TSG-RAN Meeting #16
Marco Island, FL, USA, 4 - 7 June 2002

RP-020323

Title: Agreed CRs (Release '99 and Rel-4/Rel-5 category A) to TS 25.303

CHANGE REQUEST

Figure 34: Combined Cell/URA Update and SRNS relocation (lossless radio bearers)

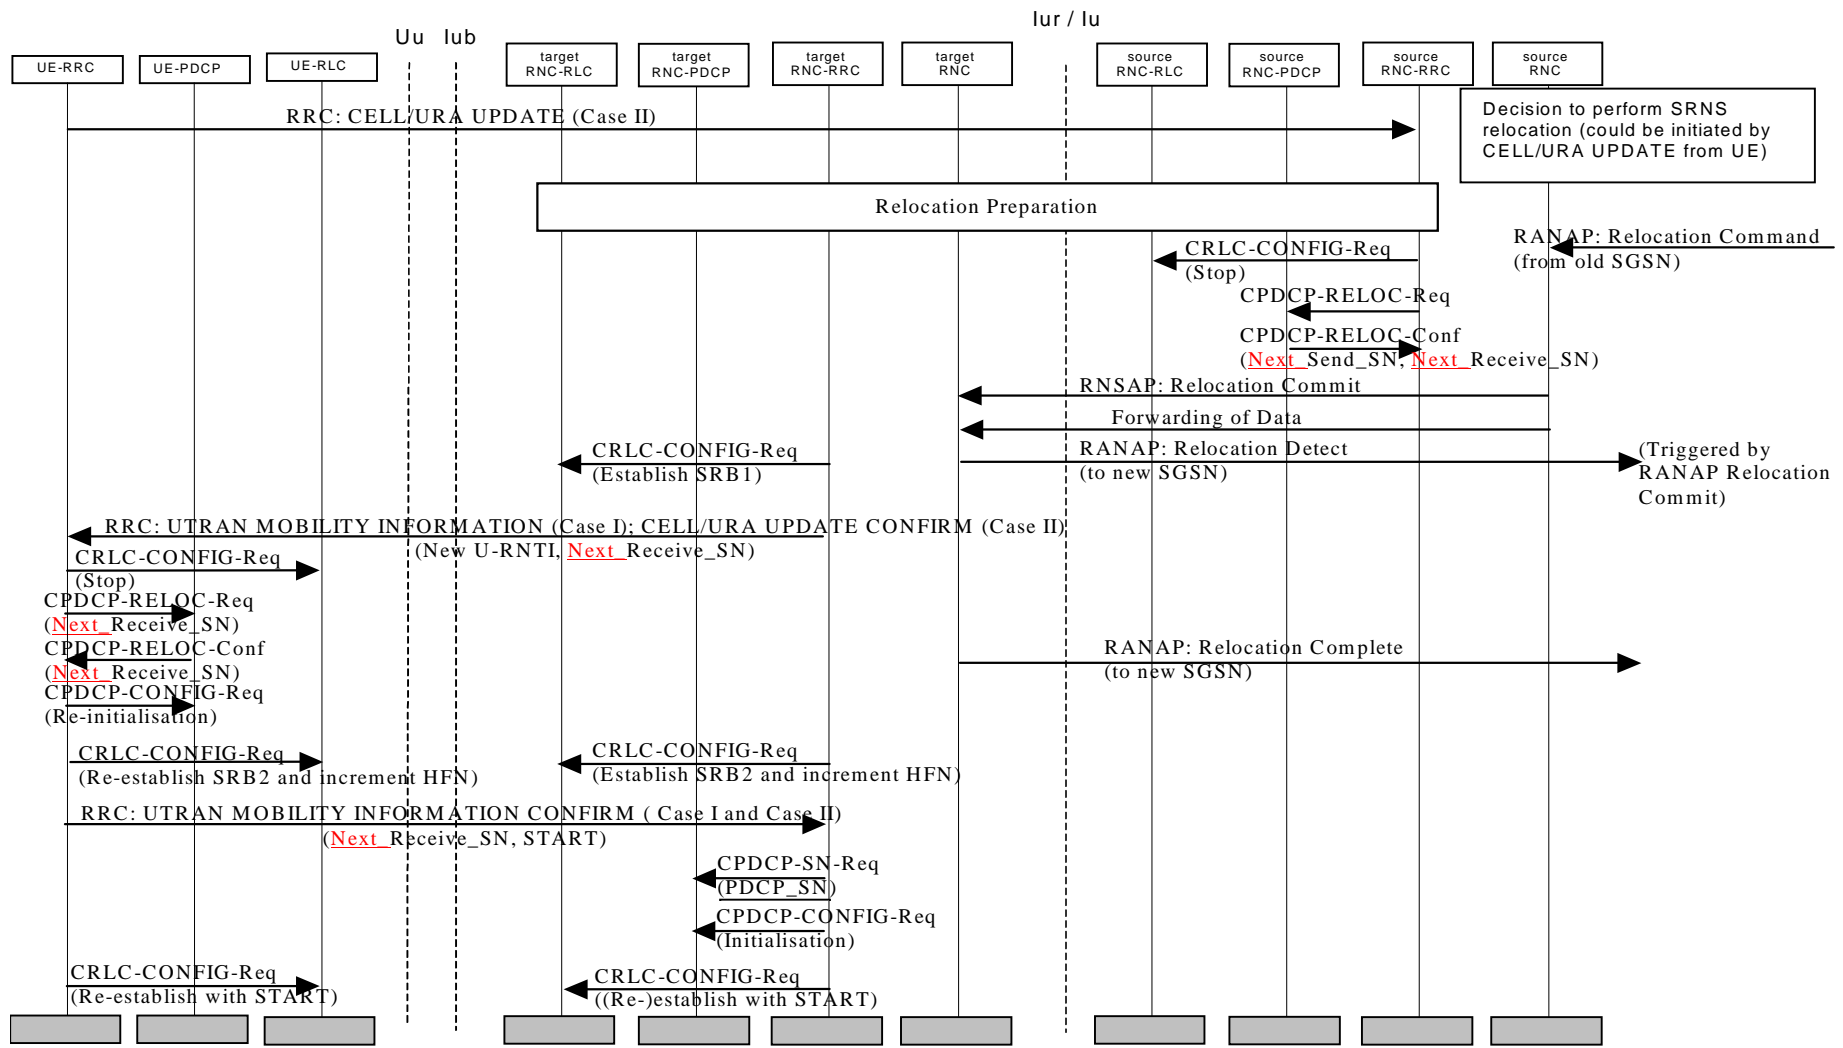
Reason for change:	⌘ At WG2 #27 meeting, "Receive_SN" and "Send_SN" are modified as "Next_Receive_SN" and "Next_Send_SN" in the agreed CR R2-020411 for TS 25.323. The related sections described in TS 25.303 should also be modified to align with that change.
Summary of change:	⌘ 1. The uplink/downlink PDCP sequence number described in section 6.4.8.1 and 6.4.8.2 is replaced with the "next" uplink/downlink PDCP sequence number. 2. "Receive_SN" and "Send_SN" are replaced with "Next_Receive_SN" and "Next_Send_SN" respectively in figures.
Consequences if not approved:	⌘ Do not align with the current release of TS 25.323.

Figure 34: Combined Cell/URA Update and SRNS relocation (lossless radio bearers)

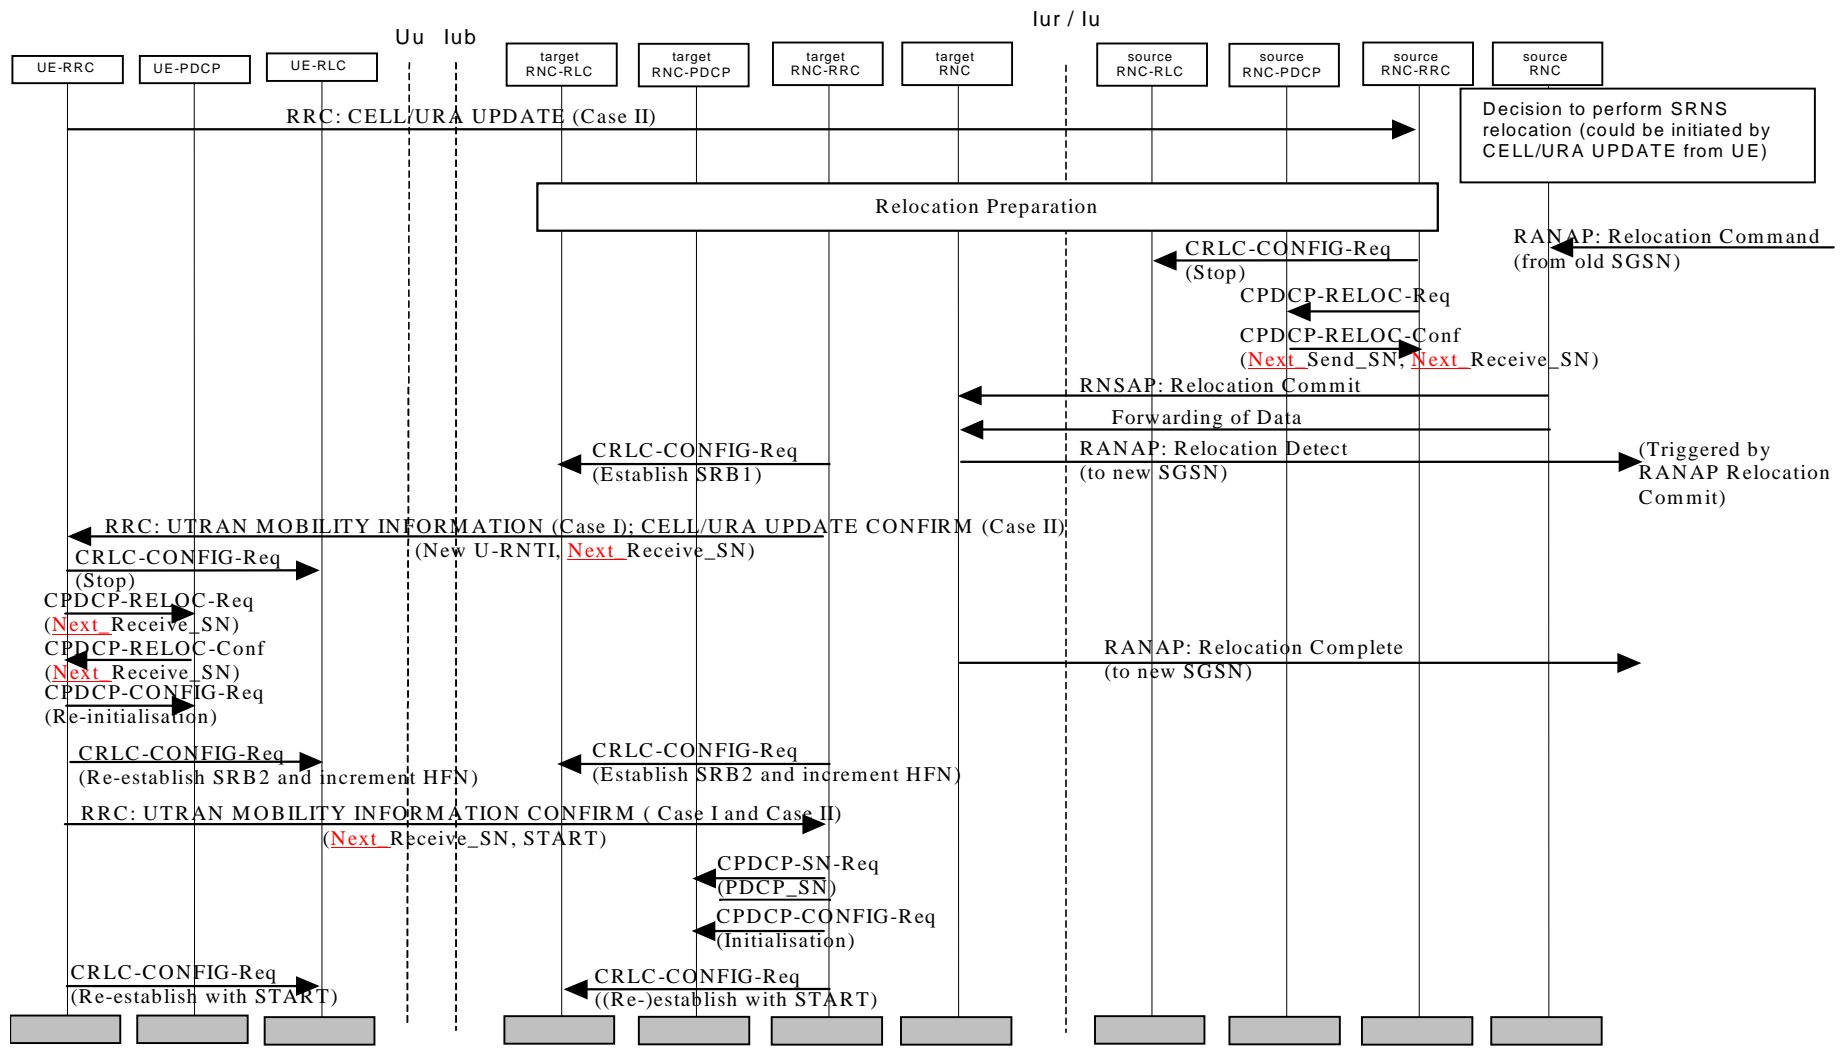
Reason for change:	⌘ At WG2 #27 meeting, "Receive_SN" and "Send_SN" are modified as "Next_Receive_SN" and "Next_Send_SN" in the agreed CR R2-020411 for TS 25.323. The related sections described in TS 25.303 should also be modified to align with that change.
Summary of change:	⌘ 1. The uplink/downlink PDCP sequence number described in section 6.4.8.1 and 6.4.8.2 is replaced with the "next" uplink/downlink PDCP sequence number. 2. "Receive_SN" and "Send_SN" are replaced with "Next_Receive_SN" and "Next_Send_SN" respectively in figures.
Consequences if not approved:	⌘ Do not align with the current release of TS 25.323.

Figure 34: Combined Cell/URA Update and SRNS relocation (lossless radio bearers)

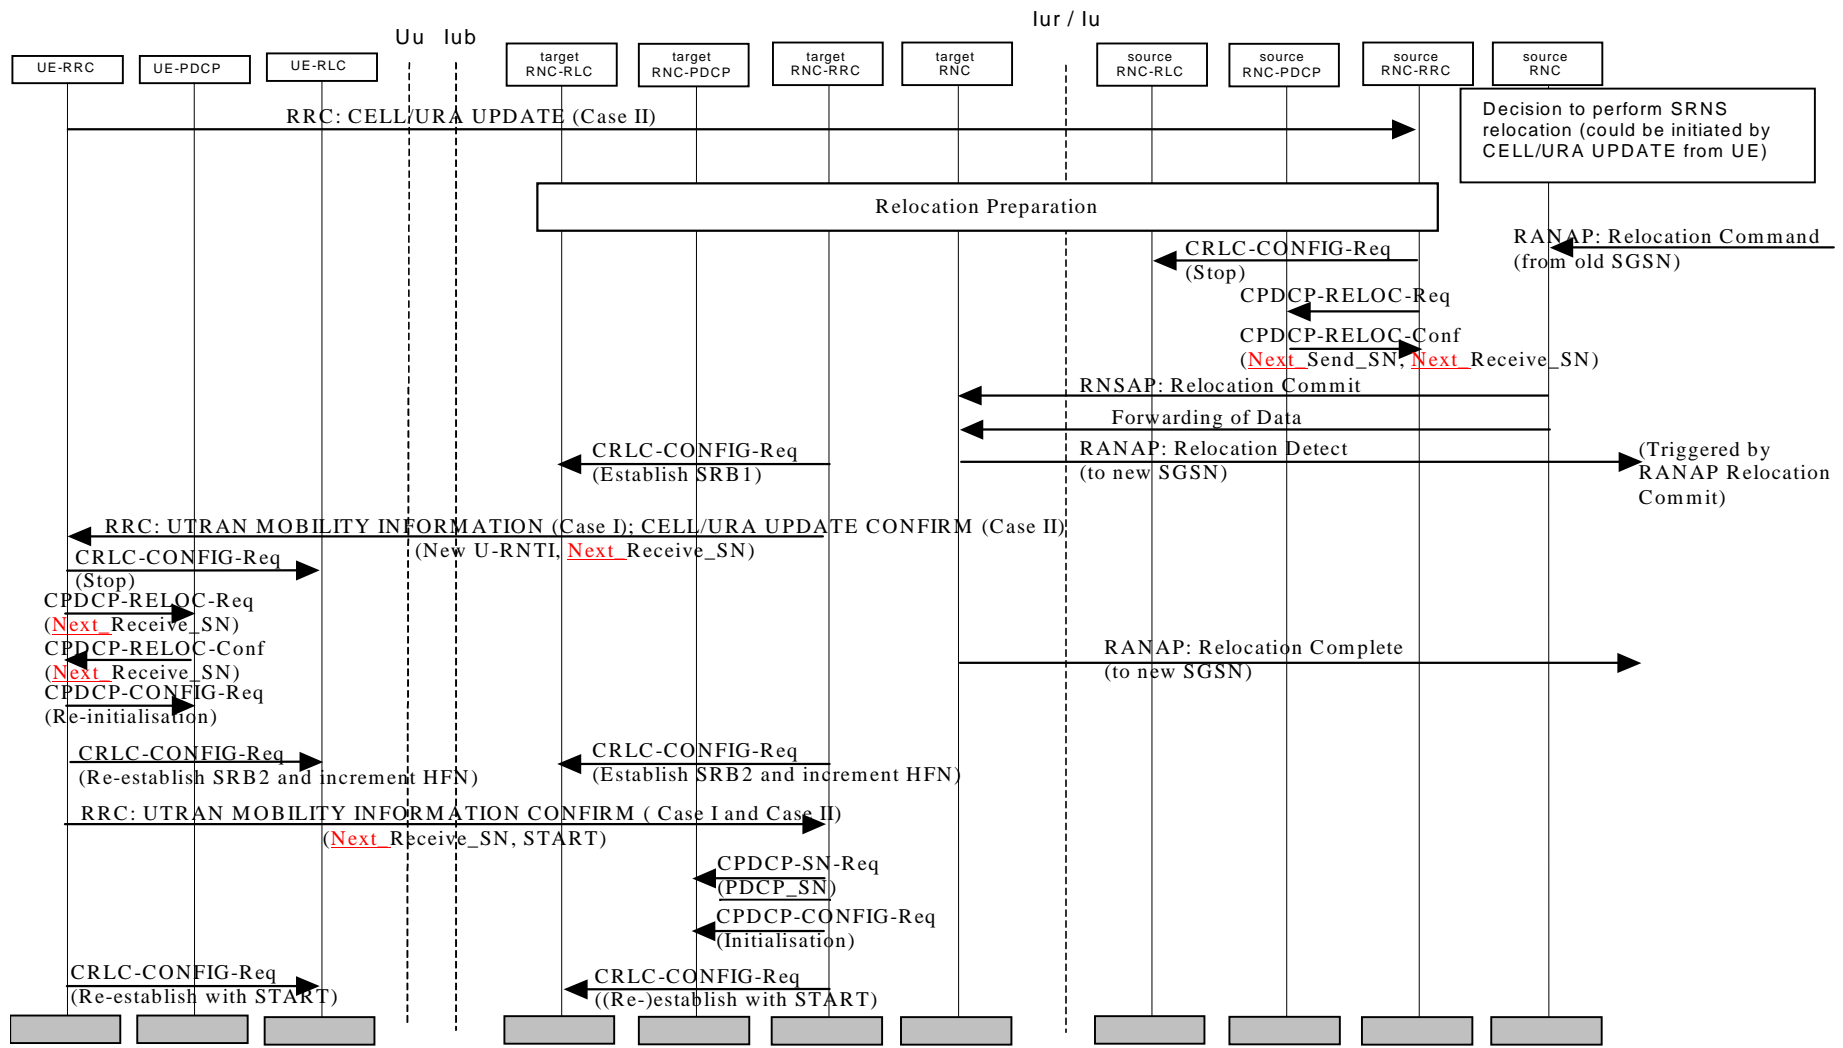
Reason for change:	⌘ At WG2 #27 meeting, "Receive_SN" and "Send_SN" are modified as "Next_Receive_SN" and "Next_Send_SN" in the agreed CR R2-020411 for TS 25.323. The related sections described in TS 25.303 should also be modified to align with that change.
Summary of change:	⌘ 1. The uplink/downlink PDCP sequence number described in section 6.4.8.1 and 6.4.8.2 is replaced with the "next" uplink/downlink PDCP sequence number. 2. "Receive_SN" and "Send_SN" are replaced with "Next_Receive_SN" and "Next_Send_SN" respectively in figures.
Consequences if not approved:	⌘ Do not align with the current release of TS 25.323.
